Product Change Note

No. 033-22

TRACO POWER TEQ 300WIR

Component removal: Knob on output voltage adjustment trim potentiometer

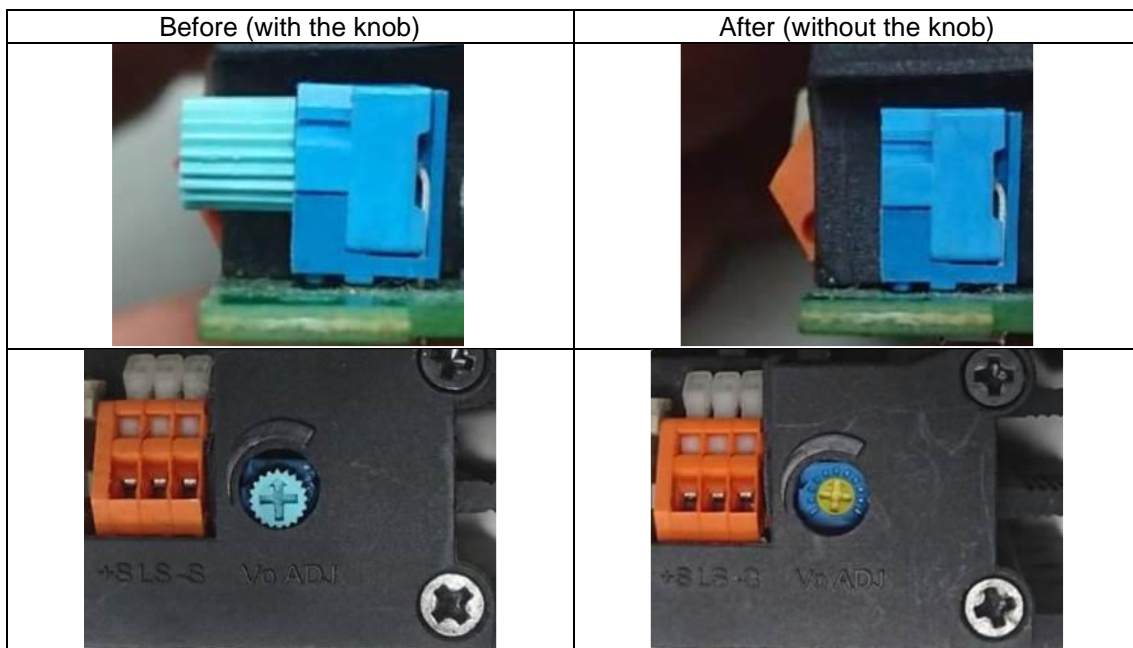
Because of production optimizations we decided to remove the knob for voltage adjustment. This causes better lead times and has no effect on the electrical and mechanical specifications. The datasheet remains unchanged.

By removing the knob, the height for adjusting the output voltage decreased by about 5 mm. A screwdriver can still be used for output voltage adjustment; there is only a change in appearance.
